**TOWN OF OCEAN RIDGE
PLANNING & ZONING REGULAR MEETING
AGENDA**

To:	Planning & Zoning Board Members
From:	Corey O’Gorman, Town Planner
Meeting Date:	September 15, 2026
Subject:	30 Oceanview – Development Plan Review

PLAN REVIEW REPORT
30 Oceanview Drive
02/16/2026/~~Revision 03/25/26~~
~~Revision 05/12/26~~
~~Revision 6/25/26~~

Subject: Site Plan Review Comments
30 Oceanview Drove (DPR)
CAS Project No. 08-26-008

REAR ELEVATION ARTICULATION DIAGRAM
SCALE : 1/4" = 1'-0"

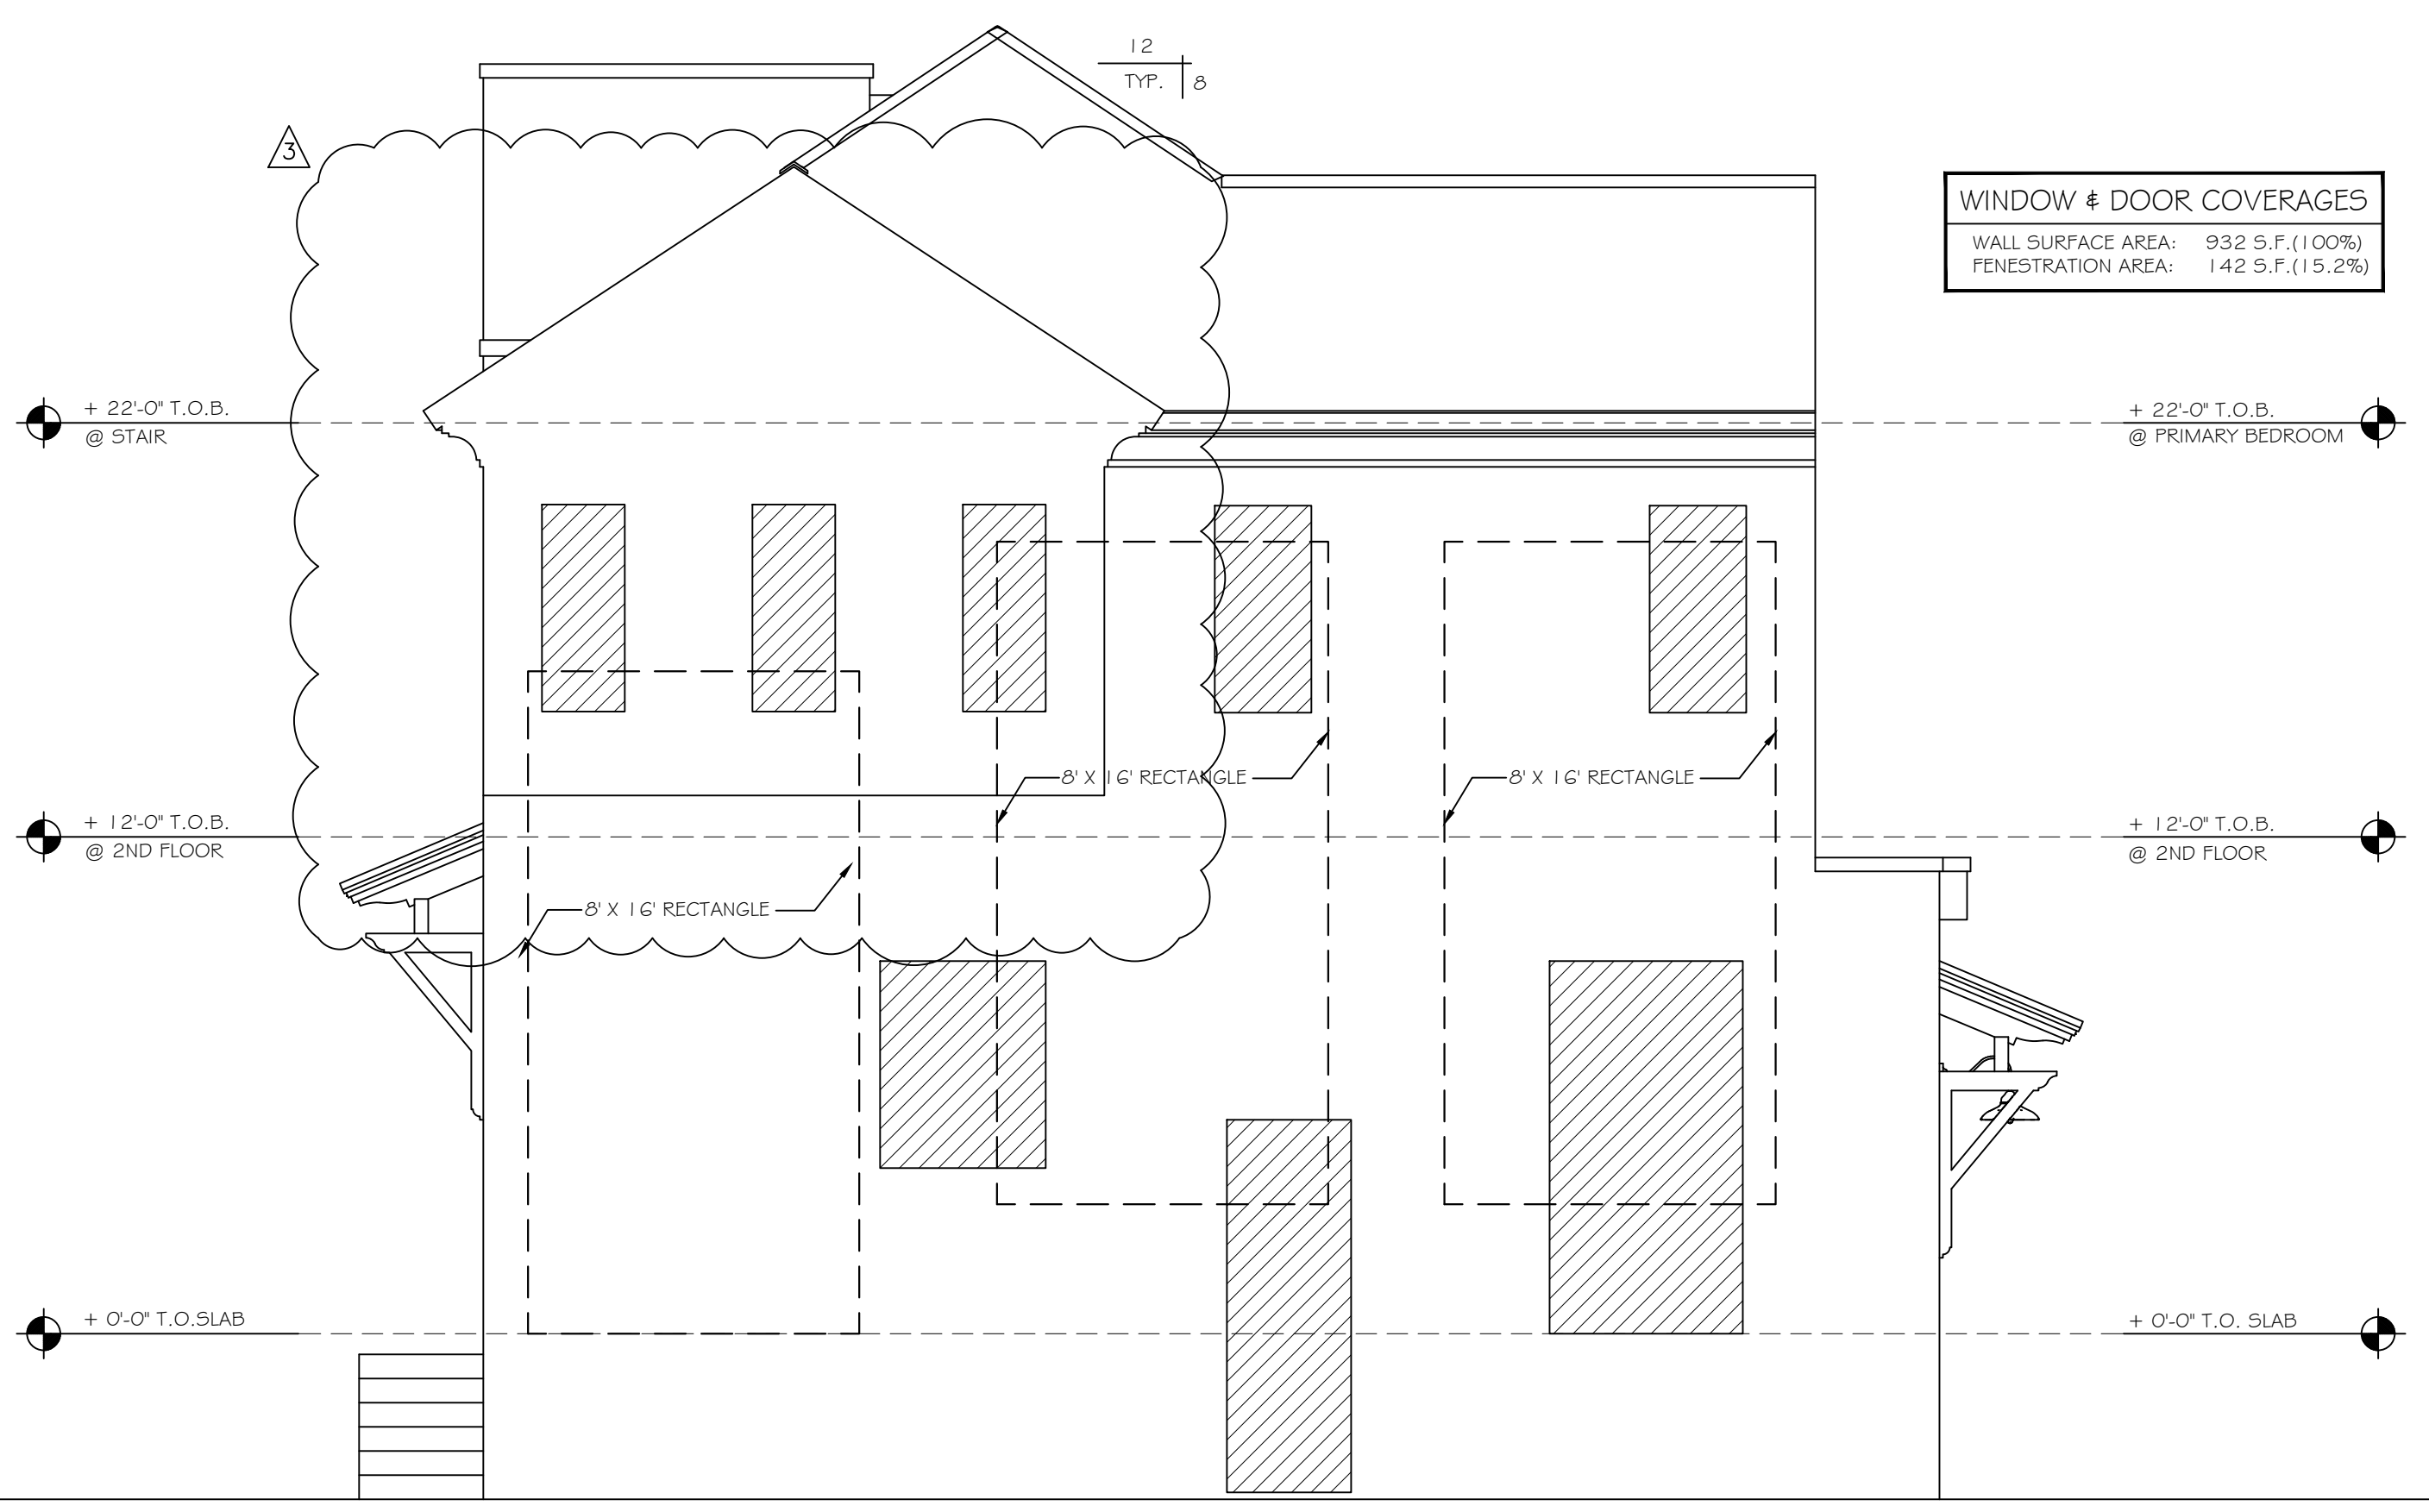
Section 64-3(d) **Background:** This code section addresses the minimum setbacks including side setback for principal structures in the Ocean View Special Area. There are several exceptions to the minimum required setbacks including 64-1(h) for dormers and gabled ends, 64-1(j)(2) for exterior balconies, bay windows, exterior chimneys, or other architectural features which do not measure more than 25 SF in the horizontal plane, and eaves which do not extend more than 3' from the vertical wall, and

64-52 for height and yard exceptions allowing a roof overhang to project into the setback. The plans show an encroachment into the side setbacks on both the east and west elevations.

The Town Code allows architectural features to encroach into the setback provided that they do not measure more than 25 SF in the horizontal plane, and eaves which do not extend more than 3' from the vertical wall, however the code does not include a definition for "architectural feature". Consequently, this report recommends approval subject to compliance with the 25 SF and 3' extension, and determination by the Planning & Zoning Board if this qualifies as an architectural feature.

The architect's response: "The encroachments have been removed. To provide an architectural feature, the plans were revised. The architectural feature will be constructed under the roof overhang as a standard over frame having a stucco finish at the second floor only, providing our decorative gable end feature." In addition, the "architectural feature" is described as a "standard over frame having stucco finish at the second floor only" and is constructed "under the roof overhang".
